Diehl Borrow Pit / M-2018-052 / Adequacy Review

Subject: Diehl Borrow Pit, File No. M-2018-054, Technical Revision 1
SEMA Construction Inc., Response to the DRMS Adequacy Comments 2020.04.06

PROJECT TITLE	DIEHL BORROW PIT
PROJECT NO.	M2018-054
PROJECT TASK	PRE-MINE/MINE PLAN MAP
TITLE OF DRAWING	TECHNICAL REVISION 1 GRADING PLAN
PROJ. NO.	10-18-08
SET #	00
SHEET SET	00
SHEET NO.	TR1

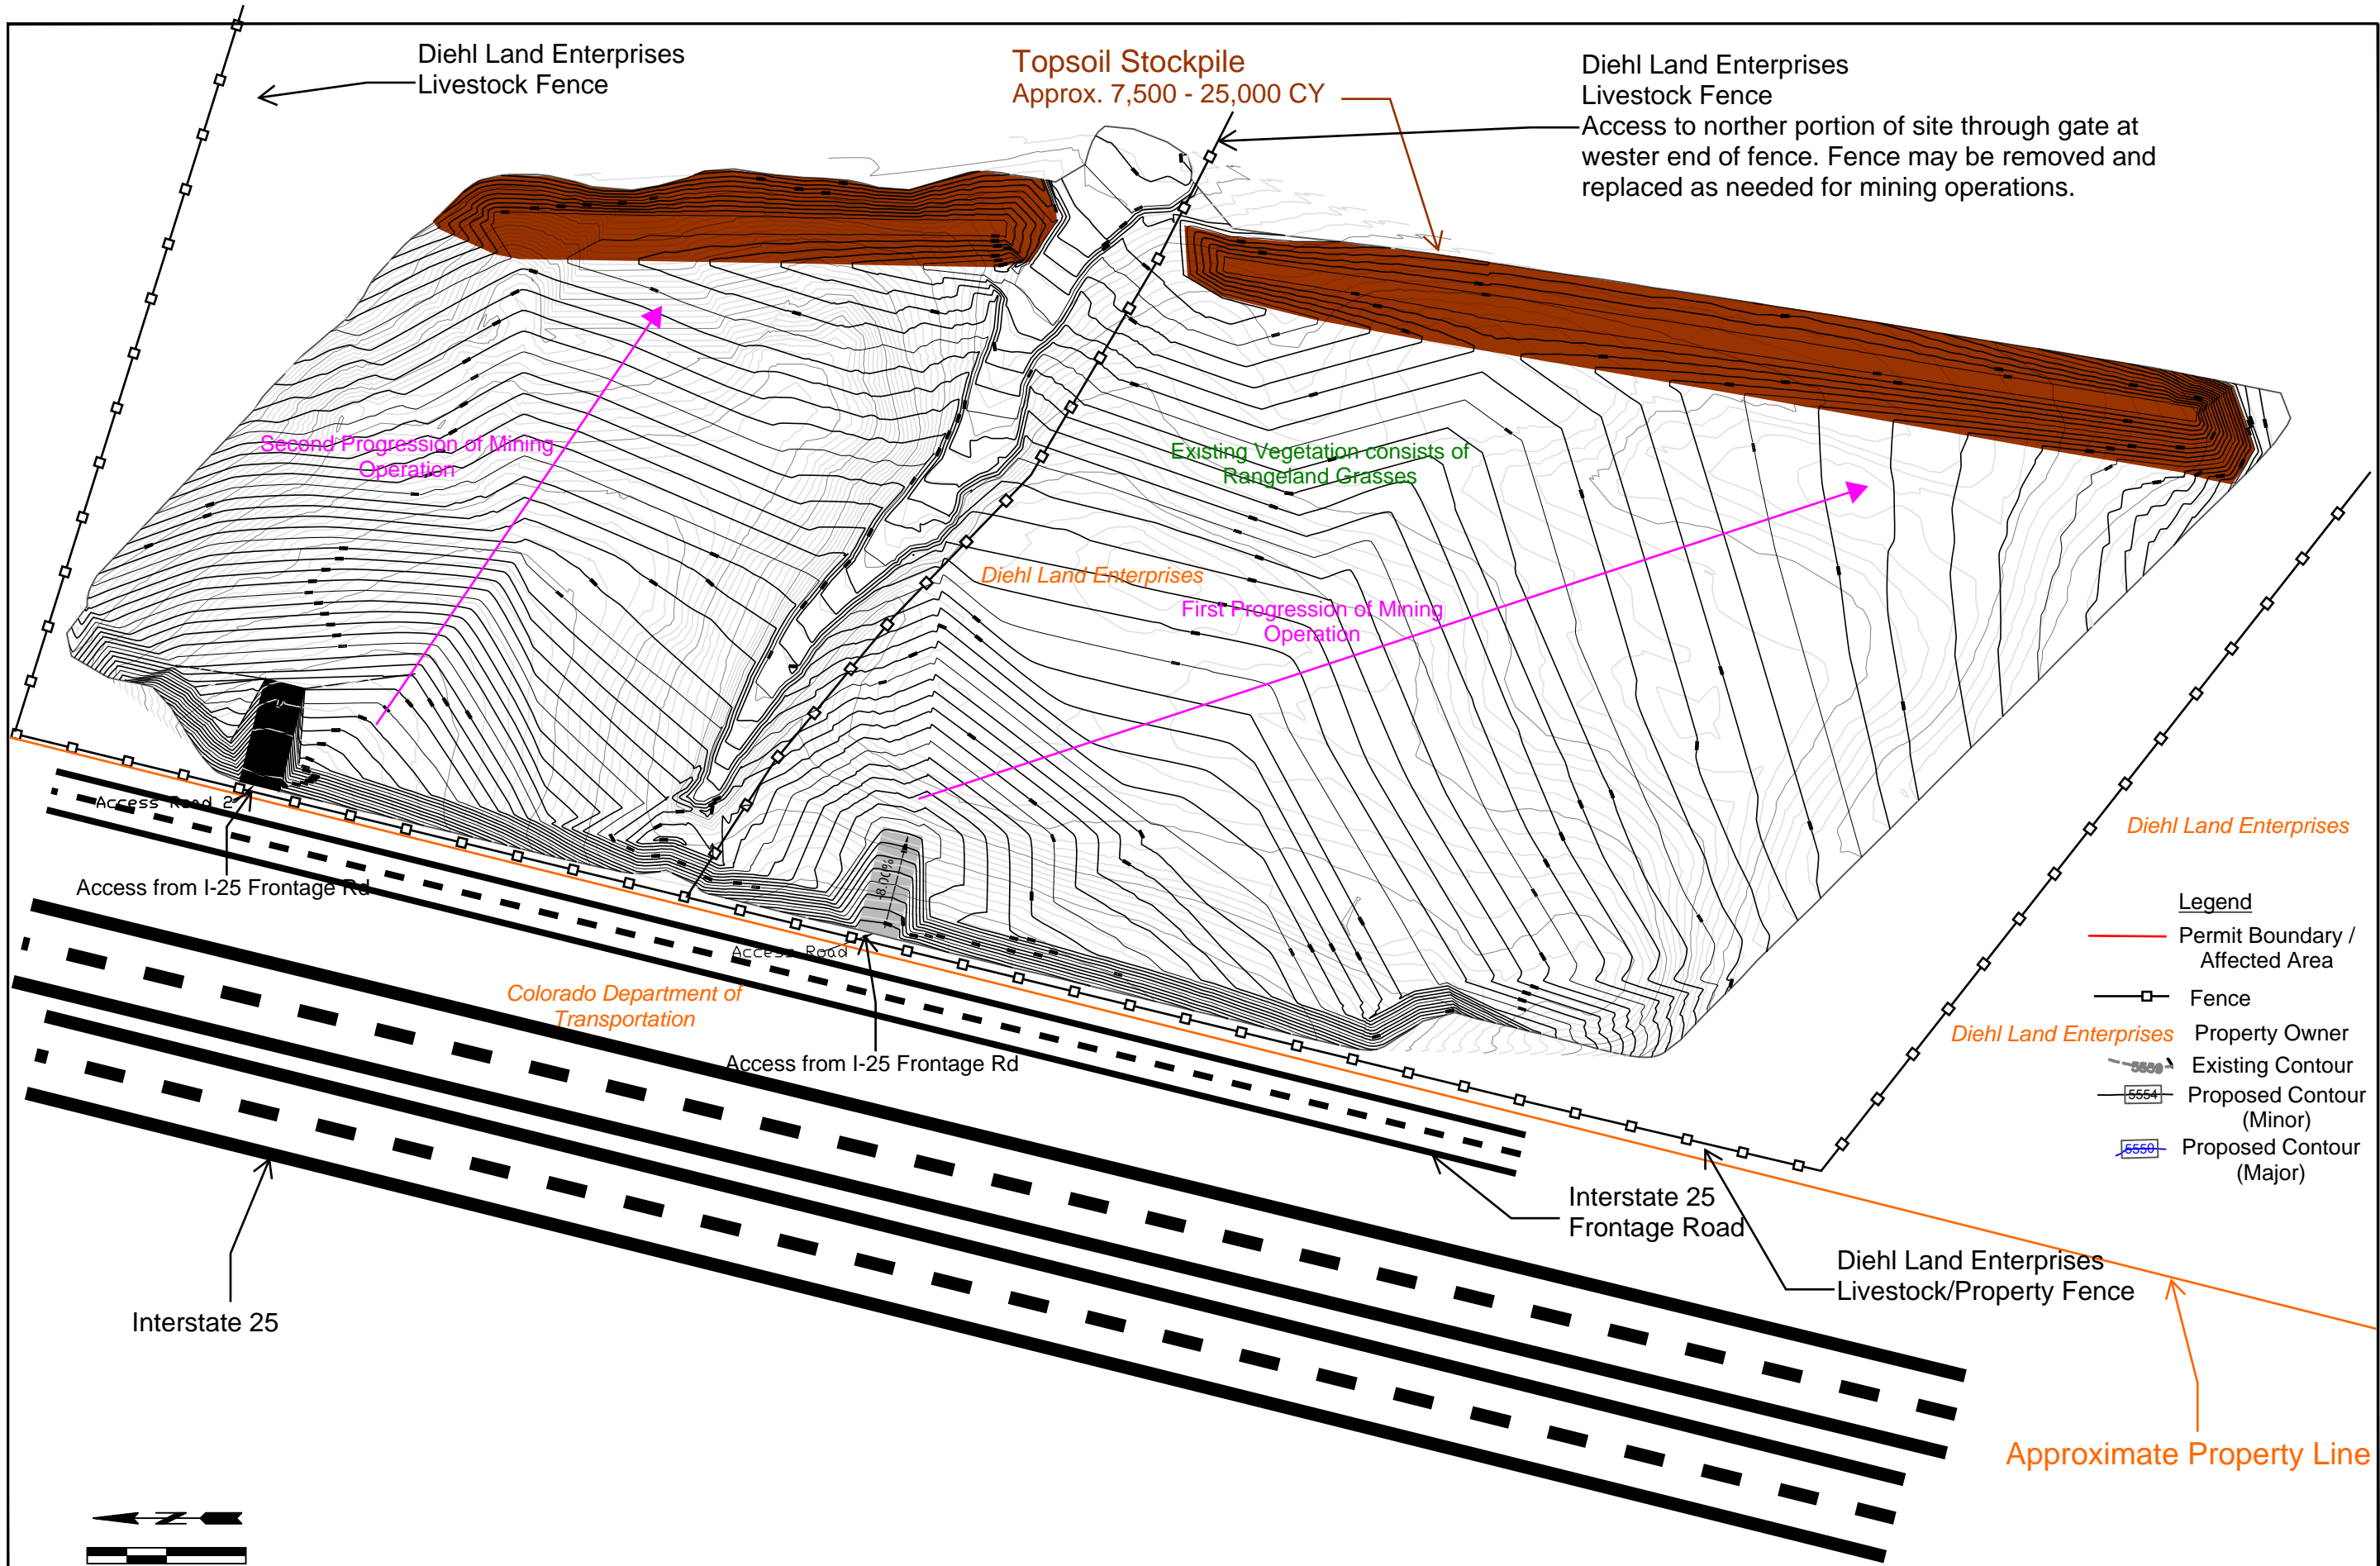
- 1) *1) On both the revised mining plan map and reclamation plan map, please include the following requirements of Rule 6.2.1(2).*
 - a. *a. Must be prepared and signed by a registered land surveyor, professional engineer, or other qualified person.*
The Mining and Reclamation Maps included in Technical Revision 1 were completed by a Colorado Licensed Professional Engineer, Cameron Mang.

- b. *Give date prepared (revised)*
Revision Date has been included on the updated plan maps. Attached for your reference.
 - c. *Include a map scale (The acceptable range of map scales shall not be larger than 1 inch = 50 feet nor smaller than 1 inch = 660 feet.)*
Map scale has been included on the updated plan maps. Attached for your reference.

- d. *Include a north arrow.*
North arrow has been included on the update plan maps. Attached for your reference.
- 2) *The revised reclamation plan map shows the two site access roads will be reclaimed. The current financial warranty held for the site includes costs for retopsoiling and revegetating the entire affected lands (26.95 acres), which would include the areas disturbed by the two access roads. Please clarify whether the reclamation plan for the access roads will involve any additional tasks (e.g., gravel removal, gate removal).*
As part of the final reclamation, the gravel will be removed, and topsoil will be placed on the mining access roads. These roads will be revegetated using the approved method outlined in the original mining application. At the request of the property owner, gates will be left in place to serve as future access for cattle grazing.

PROJECT TITLE	DIEHL BORROW PIT	
	M2018-054	
PROJECT TASK	RECLAMATION PLAN MAP	
	TECHNICAL REVISION 1 GRADING PLAN

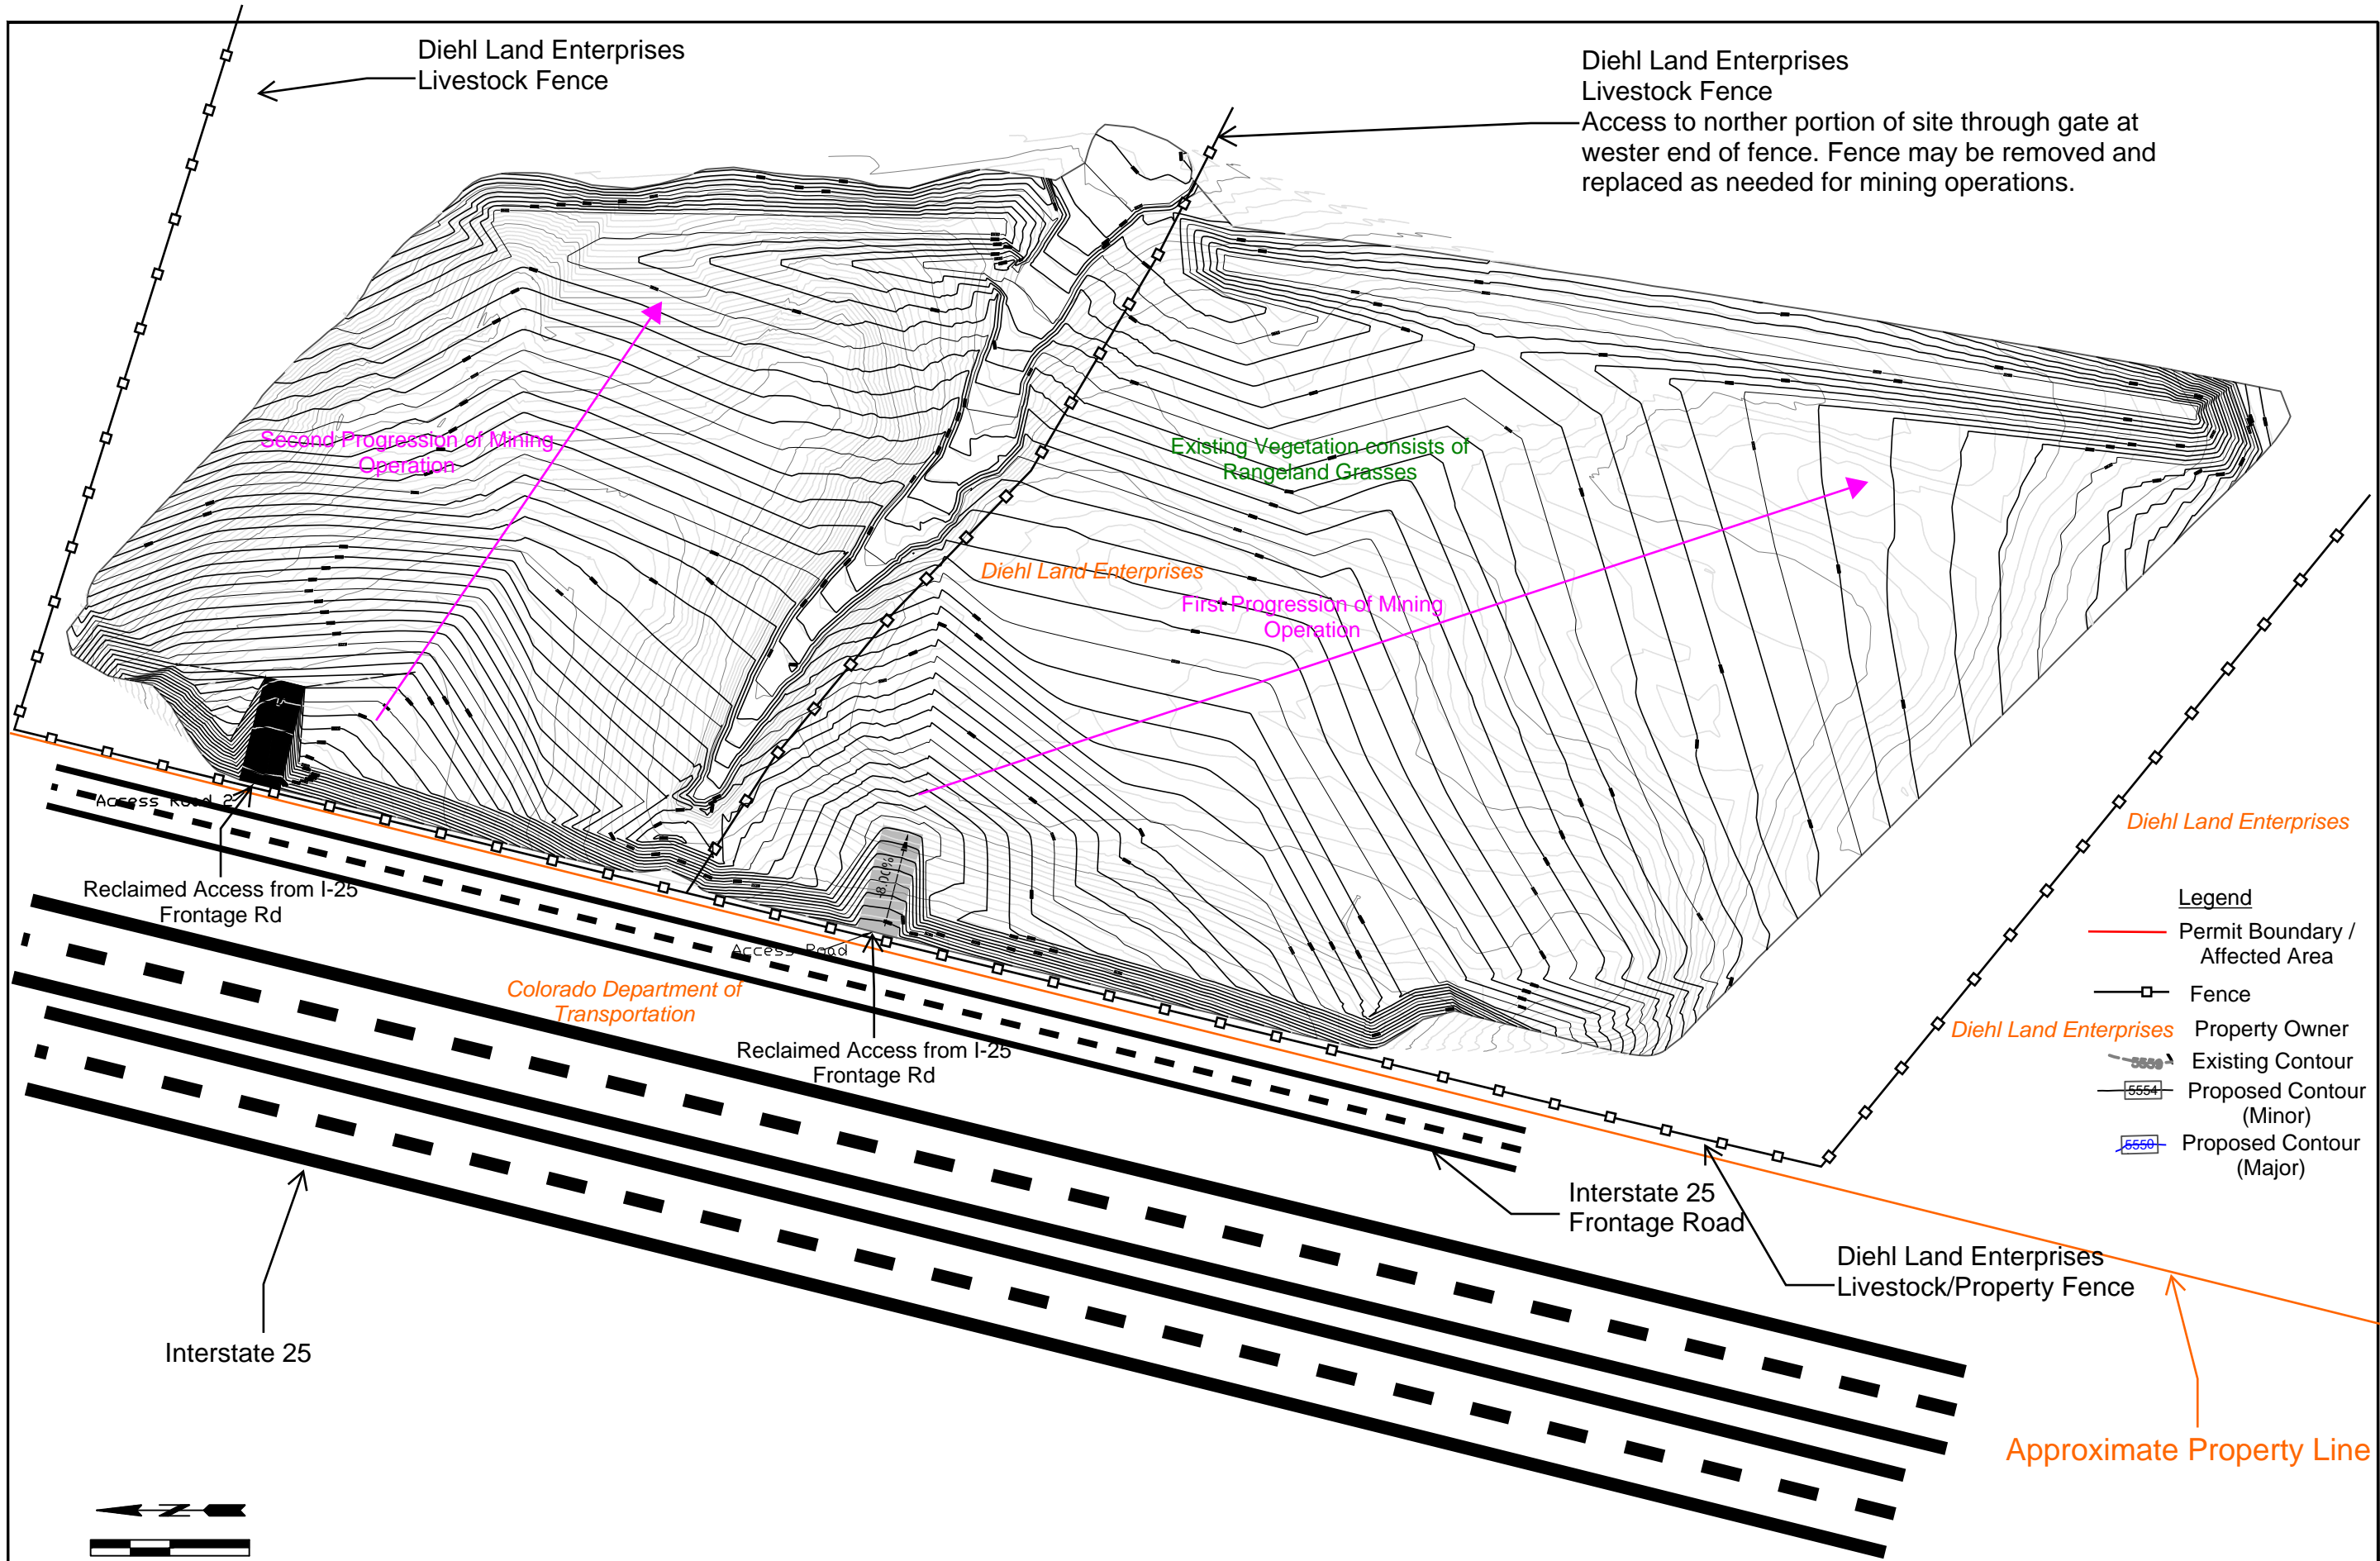
- 3) *If any additional reclamation tasks will be required for the access roads, please include an updated bond estimate that includes costs for completing these tasks. If no additional reclamation tasks will be*

required, please state as such, and the currently held financial warranty will be considered adequate at this time

No additional reclamation tasks are anticipated. The current financial warranty fully covers all work associated with gravel removal, topsoil placement and vegetation of the access roads.
